Re: Compliance Advisory for the Milner Landfill: 20650 County Road 205 Steamboat Springs, CO 80487 RTT16 CDPHERM HAZ SW - Compliance/Enforcement File:

SOLID WASTE INSPECTION WORKSHEET

Agency:	Colorado Department of Public Health and Environment Hazardous Materials and Waste Management Division			
Date:	May 25, 2023	Times: 9:00 AM - 3:00 PM		
Site:	Milner Landfill (the Facility) Twin Enviro Services 20650 County Road 205 Steamboat Springs, CO 80487			
Inspectors:	Brian Long, CDPHE HMWMD Sarah Foreman, CDPHE HMWMD			
Inspection:	Routine Compliance Inspection			
Site Representatives:	Greg Underwood, Compliance Officer, Twin Enviro Tony Matt, Operations Manager, Twin Enviro			
Other Participants:	Scott Cowman, Routt County Environmental Health			
Weather Conditions:	Mostly sunny, no precipitation

Photo 37: View showing material from compost work pad pushed down slope at southeast corner of compost work pad

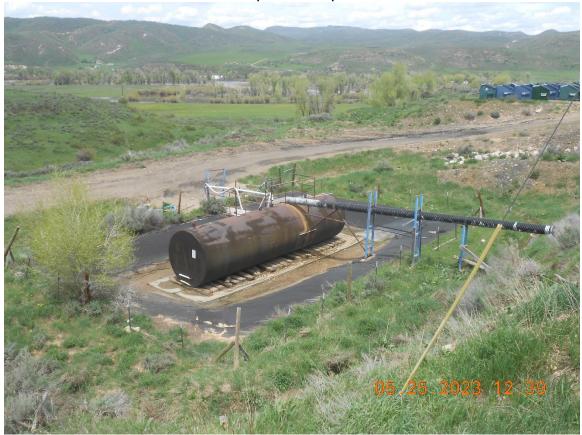
Deficiency 2: There was a substantial amount of material (mixed compost, feedstock, and woodchips) pushed over the perimeter berm on the south, west and east sides of the composting area, in apparent violation of Section 1.3.2 "Run-on/Runoff Control" of the Facility's Composting Design and Operations Plan (Appendix H to the Facility's EDOP), Section 14.4.3(B) of the Solid Waste Regulations, and CRS § 30-20-110.

Photo 35: View looking east / northeast showing compost material had been pushed down the slope on eastern side of compost area

Photo 36: Additional view of material that was pushed off compost work pad onto slope on east side of compost area

Requested Action 2: The Department requests that Twin take immediate action to stop material from being pushed over the berms surrounding the composting area of the Facility. Additionally, within thirty (30) days of your receipt of this Compliance Advisory, the Department requests that Twin clean up any material that has previously been pushed out of the compost area (especially around the south, west, and east sides of the composting area) and either return this material to the composting pad for appropriate processing as compost, or to the working face of the landfill for disposal. The Department also requests that Twin provide a short "letter report", including photographs, documenting that the areas surrounding the composting area have been cleaned up.
